Subject: Sequoyah Fuels Corporation, Docket – 40-8027
Response to Draft Safety Evaluation Report – Reclamation Plan
(TAC L52511)

ENCLOSURE 1
Reclamation Plan
Draft Safety Evaluation Report
Response to Open Issues and Confirmatory Items

Sequoyah Fuels Corporation Draft Safety Evaluation Report Open Issues and Confirmatory Items

SEQUOYAH FUELS CORPORATION	
Title: Soil Sample Locations Agland and South Borrow Areas	
PREPARED BY: SCM	Filename: Figure1RAI_OI35.dwg
Reviewed by: CLH	Figure No. 20
Date: 04Dec2006

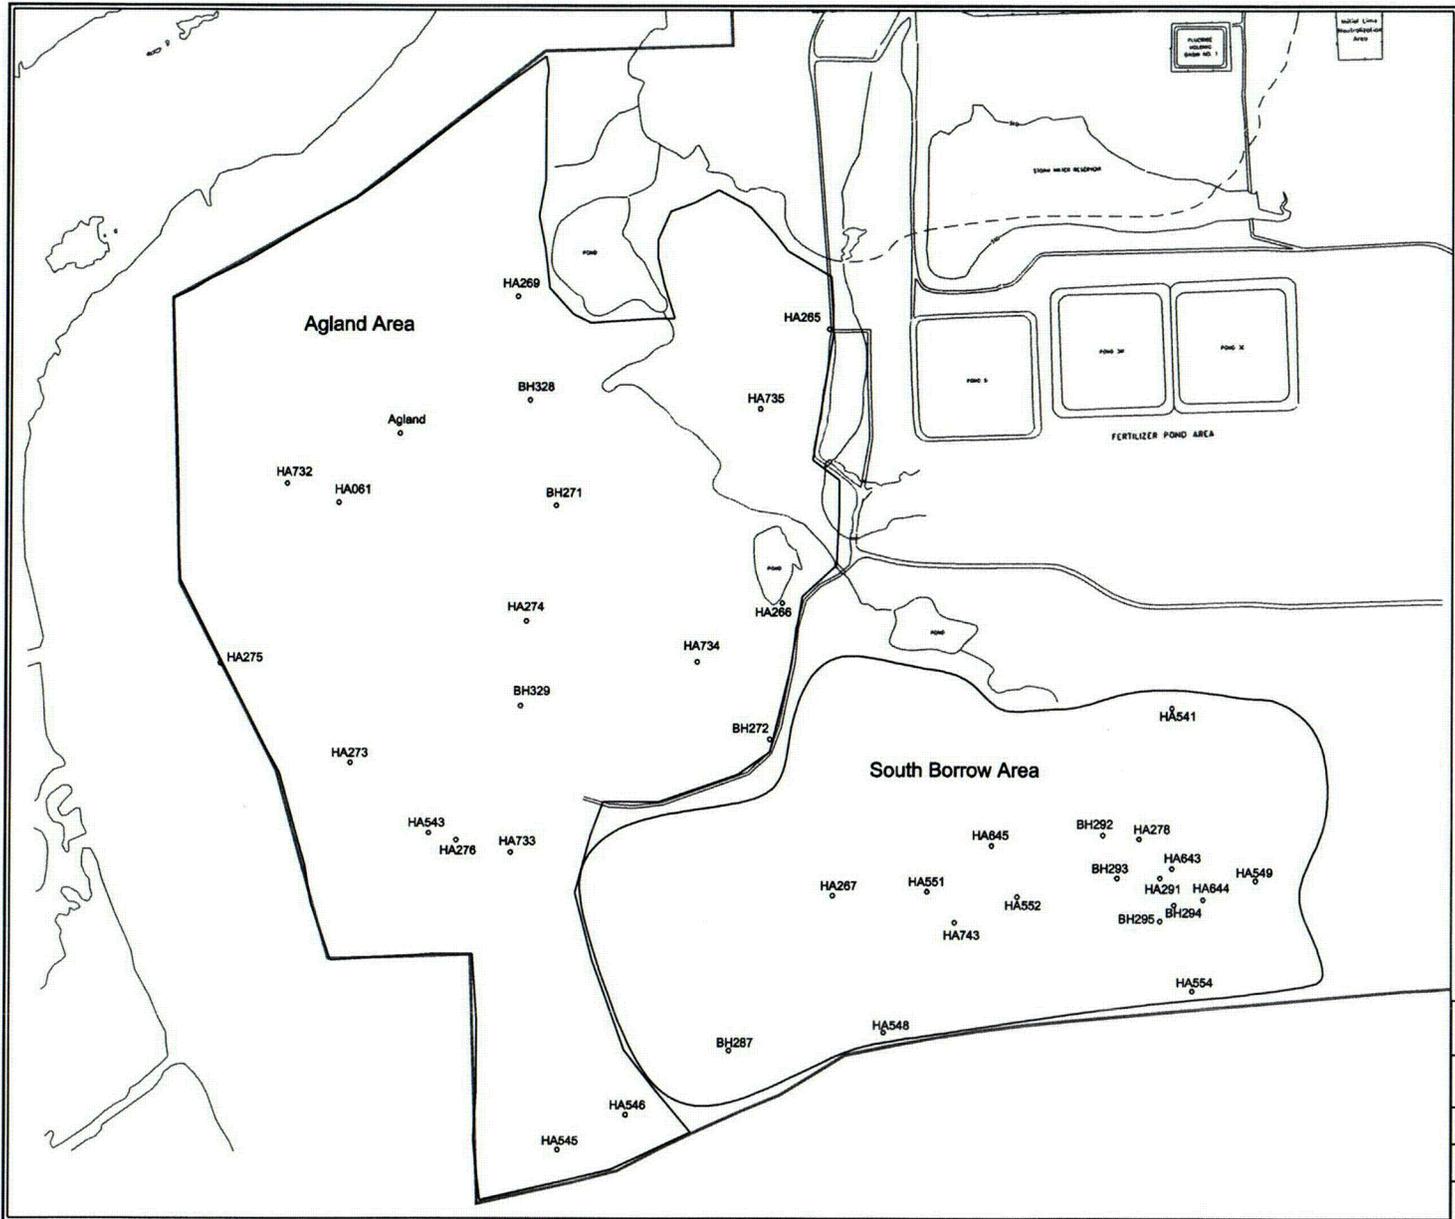
Sample analyses have been compiled for soil samples collected from background locations, South Borrow Area and Agland Area. Table 1 presents the analyses of background soil samples. Basic statistical information (number of analyses, minimum, maximum, average and standard deviation) is included. Tables 2 and 3 contain similar information for the Agland Area and South Borrow Area, respectively. The locations of the soil samples collected from the Agland and South Borrow areas are shown on Figure 20

FIGURE 24
PROPOSED ADDITIONAL DETECTION
MONITORING WELL

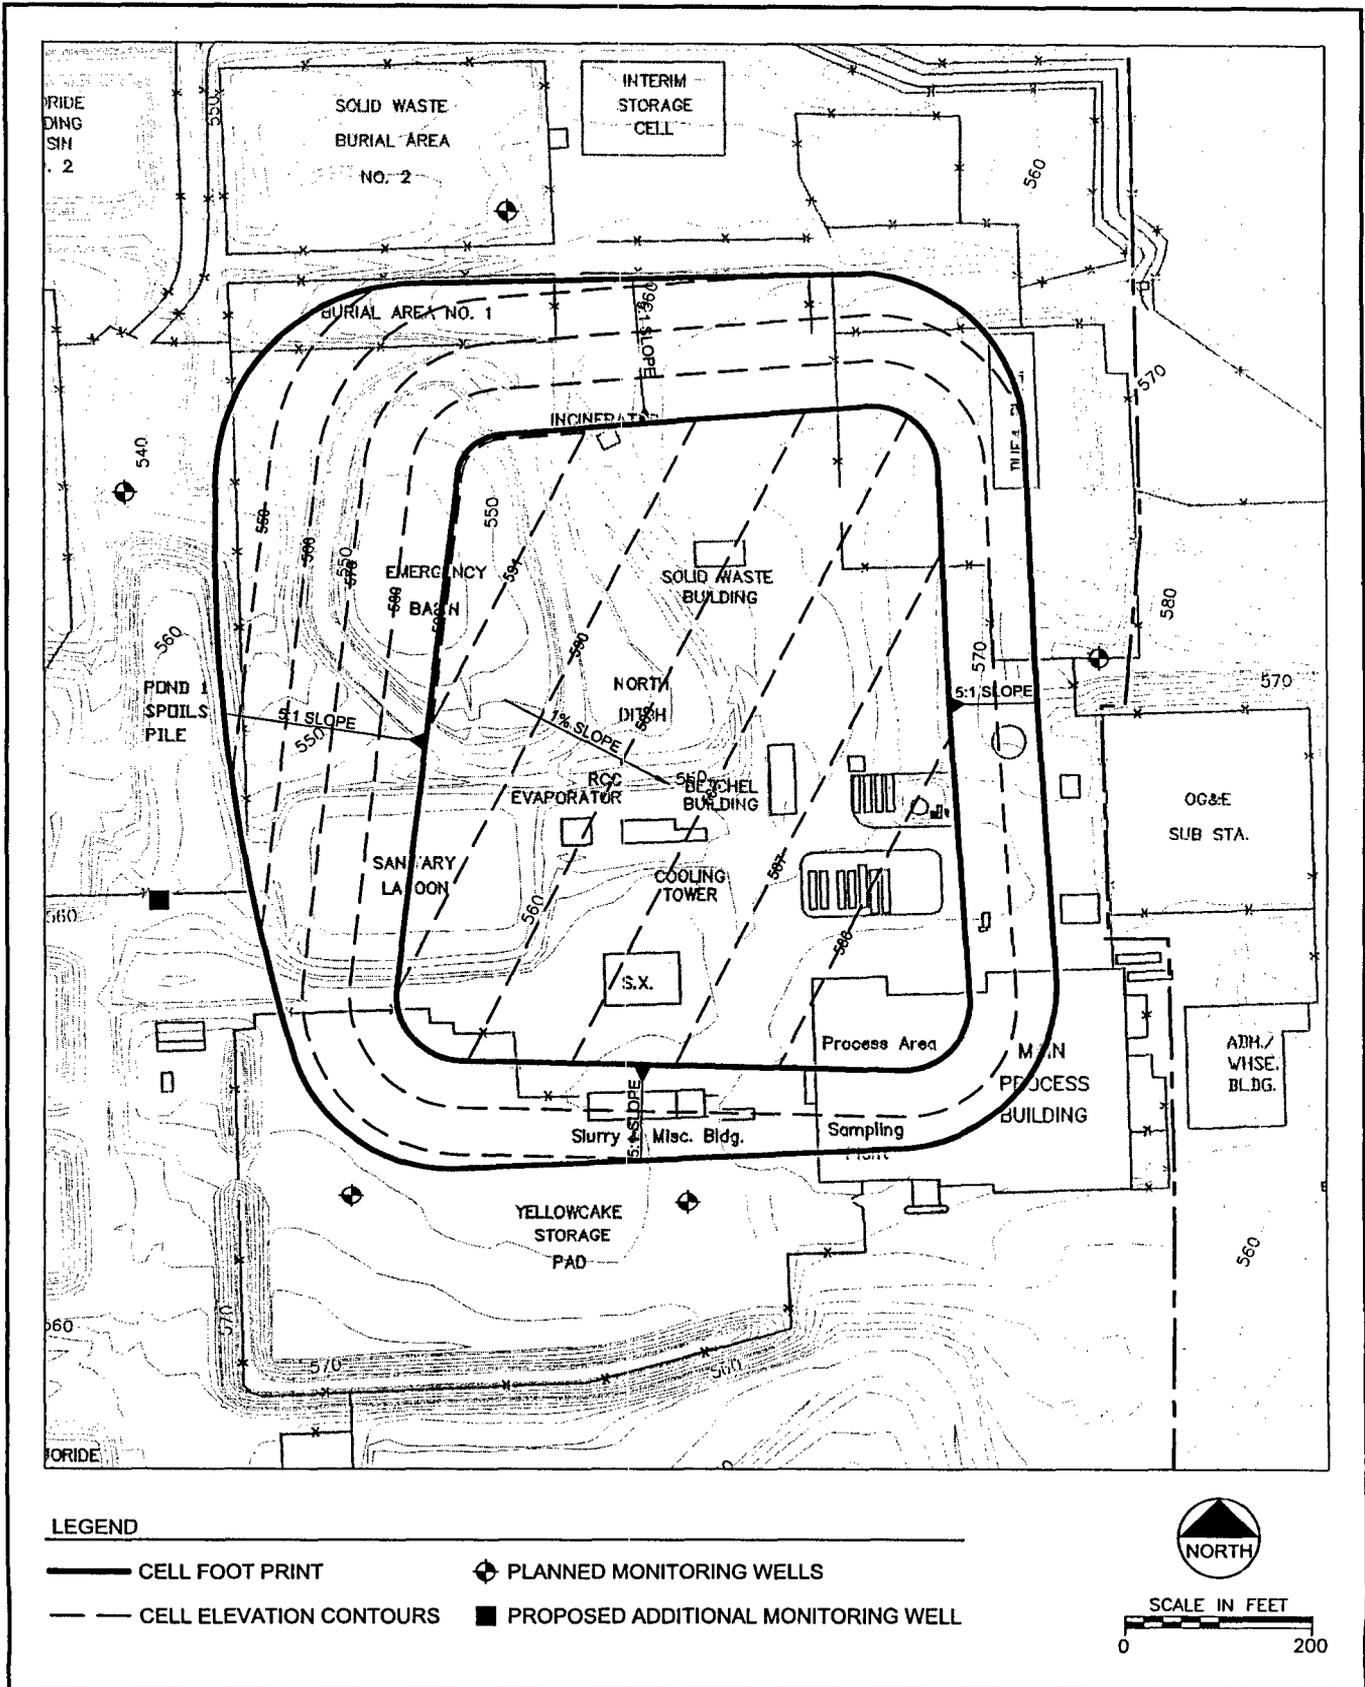
Detection monitoring wells were proposed to the north west and south west of the cell as this is the general direction for most of the historic groundwater movement in the area. However, it is recognized that cleanup activity could alter future groundwater directions in the immediate vicinity of the disposal cell. For this reason an additional well has been incorporated into the monitoring system along the west side of the cell as shown on Figure 24 enclosed with this response, and incorporated on Drawing 13 of the Technical Specifications.
